PREPARED FOR THE PLAN COMMISSION

Project Address: 710 East Mifflin Street and 124 North Livingston Street
Application Type: Demolition and Rezoning
Legistar File ID # [32794](#) and [32797](#)
Prepared By: Heather Stouder, AICP, Planning Division
Report Includes Comments from other City Agencies, as noted

Existing Zoning of Subject Site

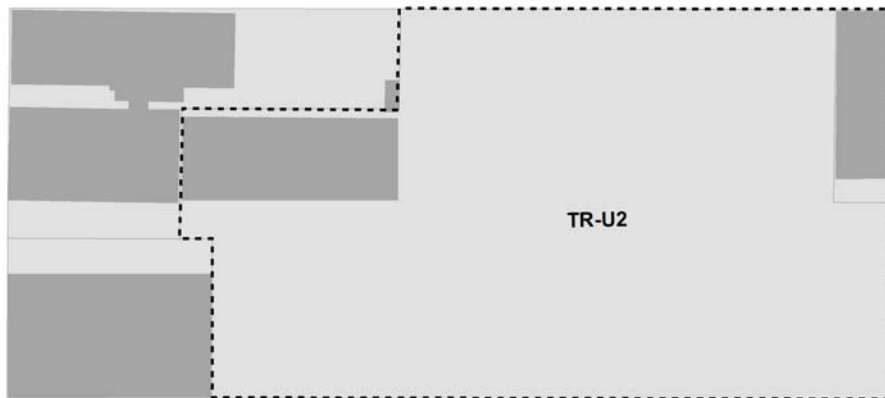
However, due to a nuance in the zoning code, staff recommends that for the time being, the zoning immediately surrounding the existing brick building on the property remain PD, and that the remainder of the property be rezoned to TR-U2. As has been noted, staff understands that conversion of the existing building to residential use could not occur in an early phase of the project, and that it will likely continue to be utilized for storage for the foreseeable future. If the entire property were to be rezoned to TR-U2 at this time, the use of the building would become a legal non-conforming use, which is not inherently problematic. The issue is that zoning requirements would prohibit the construction of a new multi-family residential building on the same property with a non-conforming use. Thus, as long as the non-conforming use was to continue in the TR-U2 District, no residential development could occur on the site.

As a solution, staff recommends that the area surrounding the existing building remain in the PD District as it is today, with a zoning text specifically allowing for the current use to continue, and that the remainder of the property be rezoned to TR-U2 at this time. If this applicant or a future property owner wishes to pursue conversion of the existing building for residential or other uses, a rezoning of the property surrounding the building could be requested again at that time, providing a better opportunity for review of the relationship between the existing building and any new development on the site. Staff understands that the applicant and the existing tenant in the building are both supportive of this solution (see illustrations on following page, with subject property outlined in dashed line).
